Indian Point Energy Center

2 correct answers on Administrative JPM for emergency event classification.

March 28, 2003
IP-TNG-03-018

SENIOR REACTOR AND REACTOR OPERATOR INITIAL EXAMINATION –
INDIAN POINT STATION, UNITS 2 AND 3

Containment Pressure Response Curves from the FSAR and Simulation are attached.

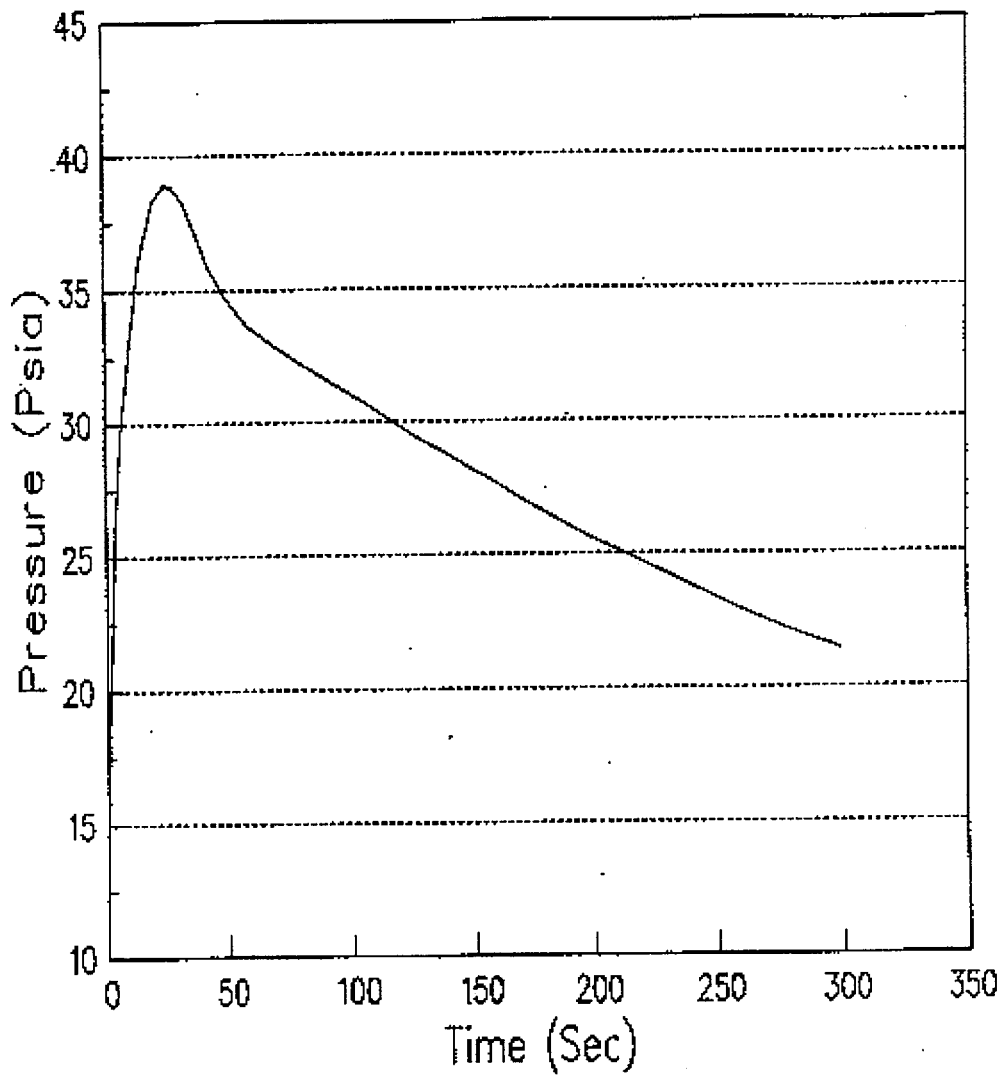
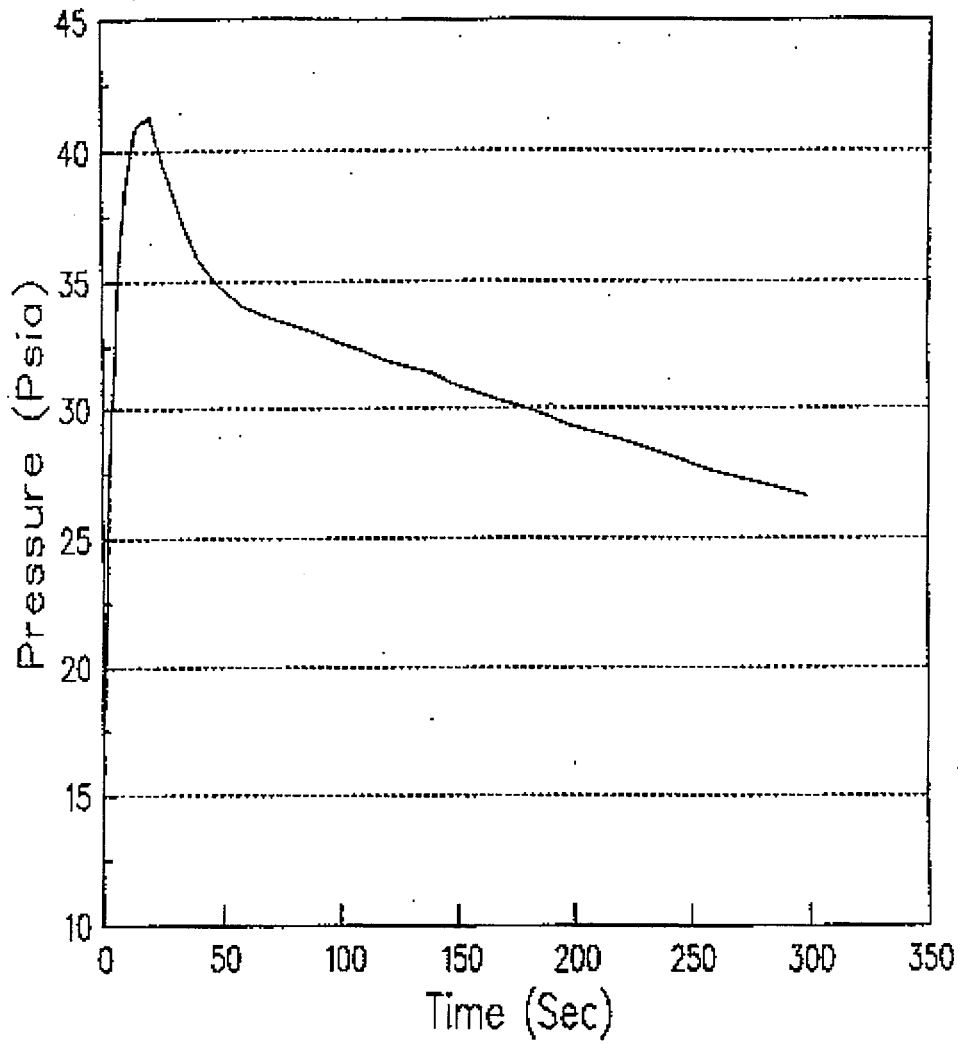
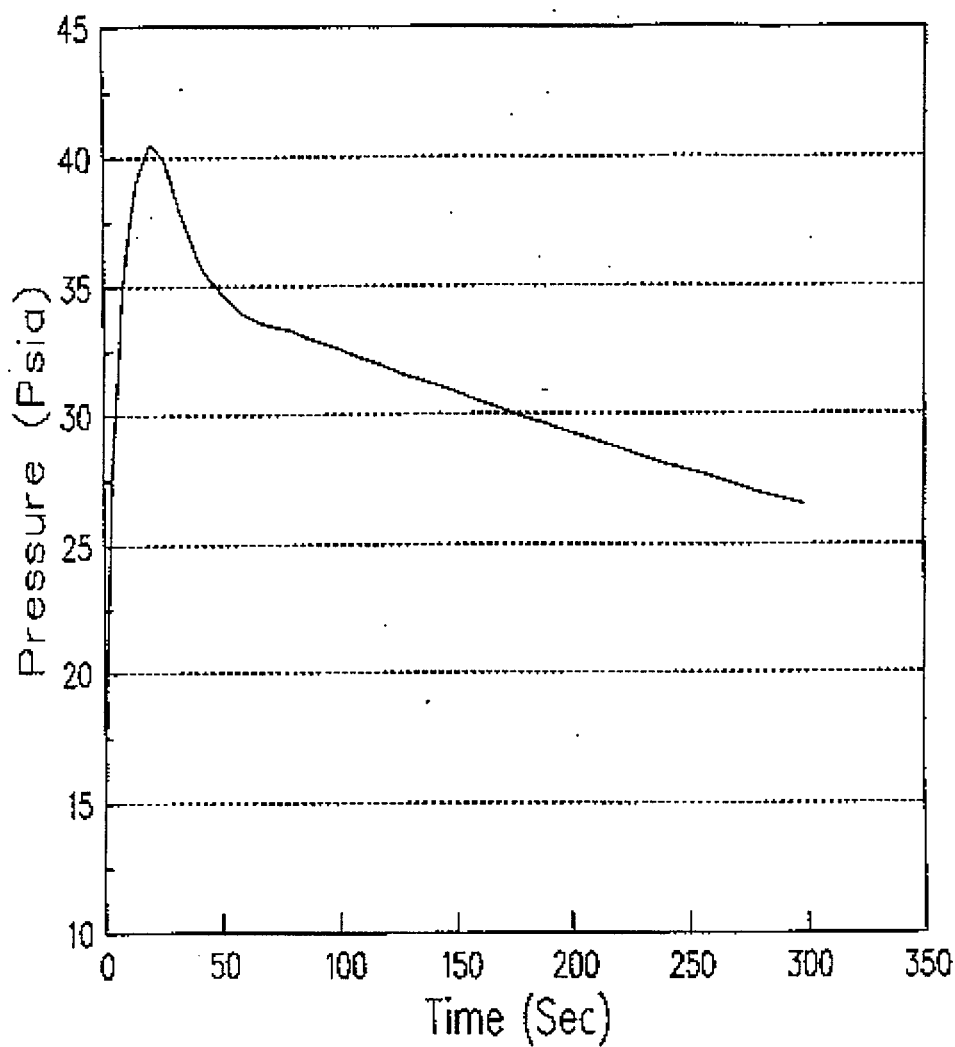
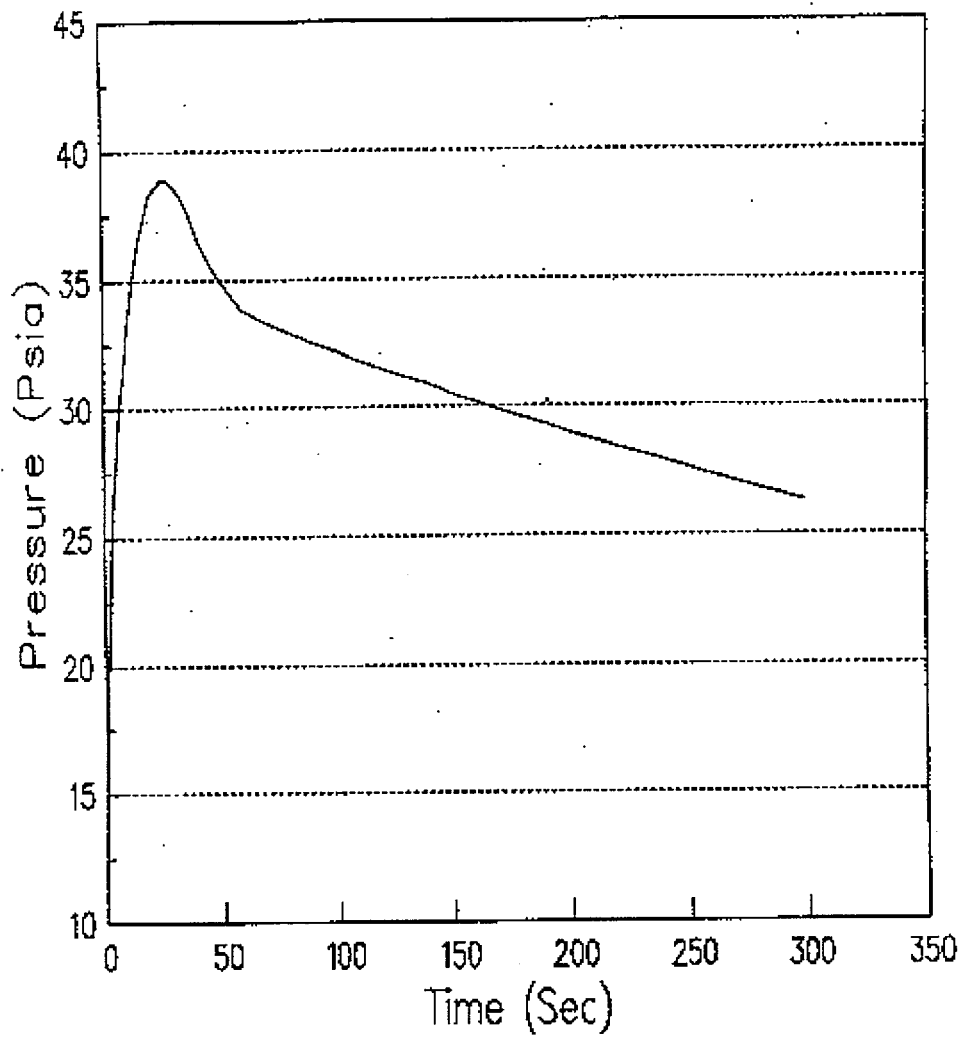
A high percentage of the applicants applied the following thought process when evaluating the Containment Barrier:

LOCA occurs and E-0 is entered. Time spent in E-0 is approximately 10-15 minutes. Based on the conditions provided, FR-C.2 is entered upon exit of E-0. Time spent in FR-C.2 is approximately 10-15 minutes. FR-P.1 is entered when FR-C.2 is exited. Time spent in FR-P.1 is approximately 5-10 minutes. E-1 is entered when FR-P.1 is exited.

Based on 25-40 minutes into the accident sequence, with equipment functioning as specified in the JPM conditions, containment pressure will be in the single digits. A review of the FSAR and simulated accident on the IP2 simulation fully support this containment pressure response.

The applicants that applied this mental model came to the correct event classification of Site Area Emergency – Loss or potential loss of 2 barriers with the Containment Barrier remaining intact.
